# Agenda Item # 1 - HOLDOVER

## SUB-003605-2026

Resubdivision of Ledian M. Williams Subdivision

- Subdivision approval to create two (2) legal lots of record from two (2) legal lots of record.

# DETAIL SITE PLAN

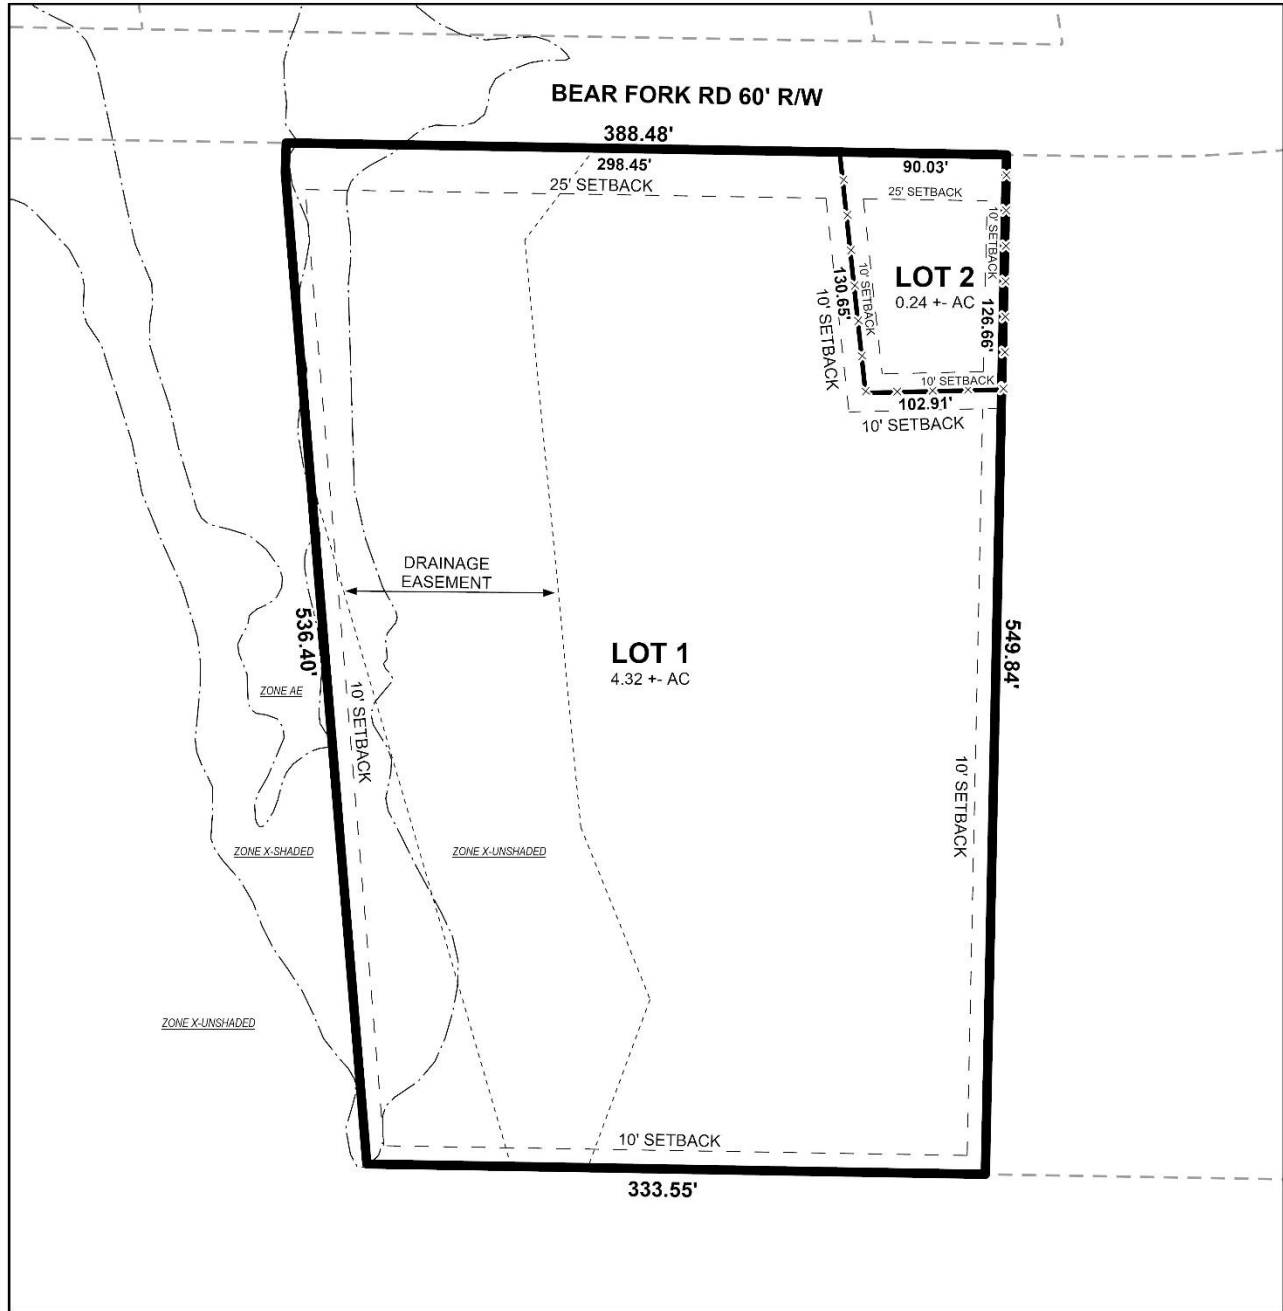
The applicant submitted a revised preliminary plat that depicts the existing dwelling on proposed Lot 2. The dwelling encroaches entirely into the required side yard setback along the east property line. However, aerial imagery indicates the structure was constructed prior to 1984, which suggests the encroachment may constitute a legal nonconforming condition.

No other structures are depicted on the revised plat. An accessory structure shown on internal mapping sources appears to have been demolished sometime after 2017.

- A. Provide all of the required information on the SUBDIVISION PLAT (i.e. signature blocks, signatures, certification statements, written legal description, required notes, legend, scale, bearings and distances) that is required by the current Alabama State Board of Licensure for Professional Engineers and Land Surveyors.

- B. Add Derrick McMillian to the Notary statement as one of the Owners.
- C. Add the site location to the vicinity map.
- D. Revise SURVEYOR'S NOTES #6 to include the AE flood zone.

- E. Show and label the MFFE (Minimum Finished Floor Elevation) on each lot that contains an A, AE, or X (shaded) flood zone designation. BFE = 40.
- F. Retain ENGINEERING COMMENTS #2-6.

- G. Revise ENGINEERING COMMENTS #1 to - As shown on the 1984 aerial photo LOTS 1 - 2 will share the 4,200 sf of historical credit of existing (1984) impervious area towards stormwater detention requirement per Mobile City Code, Chapter 17, Storm Water Management and Flood Control) and share the 8,000 SF credit provided to the original SF residential lots as follows: LOT 1 – 6,100 sf and LOT 2 – 6,100 sf. Stormwater detention will be required for any additional impervious area that exceeds the allowable credit for that LOT.

The proposed lots have frontage along Bear Fork Road, a Minor Arterial Street with a 60-foot-wide right-of-way at this location. The preliminary plat depicts sufficient right-of-way; therefore, additional dedication should not be required.

Each proposed lot meets the minimum area requirements of Article 2, Section 64-2-5.E. of the Unified Development Code (UDC) for lots served by public water and sanitary sewer within the R-1, Single-Family Residential Suburban District. Lot areas are labeled in both square feet and acres on the preliminary plat. If approved, this information should be retained on the Final Plat. Alternatively, the same information may be provided in a table on the Final Plat, if approved.

A 25-foot front yard setback is illustrated along each street frontage, consistent with Article 2, Section 64-2-5.E. of the UDC and Section 6.C.8. of the Subdivision Regulations. This information should be retained on the Final Plat, if approved.

Side and rear yard setbacks are also illustrated on the preliminary plat; however, this information is not required on the Final Plat and should be removed, if approved.

A large drainage easement is depicted on Lot 1. As such, if approved, a note should be placed on the Final Plat stating no structures are permitted in any easement without permission from the easement holder.

Staff notes that a comparison of the proposed lot lines for Lot 2—currently developed with a single-family dwelling and an apparent accessory structure—to the lot lines shown in the City's internal mapping system indicates that the proposed subdivision may create potential zoning violations. Specifically, the reduction in lot size may result in the existing dwelling encroaching into the required side and/or rear yard setbacks. Additionally, the proposed lot line adjustments would place the accessory structure on the currently vacant lot, which would not be permitted unless that lot were developed with a principal structure.

1. Retention of the 60-foot-wide right-of-way along Bear Fork Road on the Final Plat;
2. Retention of the lot size labels in both square feet and acres, or the provision of a table on the Final Plat with the same information;
3. Retention of the 25-foot front yard setback along Bear Fork Road on the Final Plat;
4. Removal of side and rear yard setbacks from the Final Plat;
5. Placement of a note on the Final Plat stating no structures are permitted in any easement without permission from the easement holder;
6. Compliance with all Engineering comments noted in the staff report;
7. Compliance with all Traffic Engineering comments noted in the staff report;
8. Compliance with all Urban Forestry comments noted in the staff report;
9. Compliance with all Fire Department comments noted in the staff report; and
10. Full compliance with all other applicable codes and ordinances.
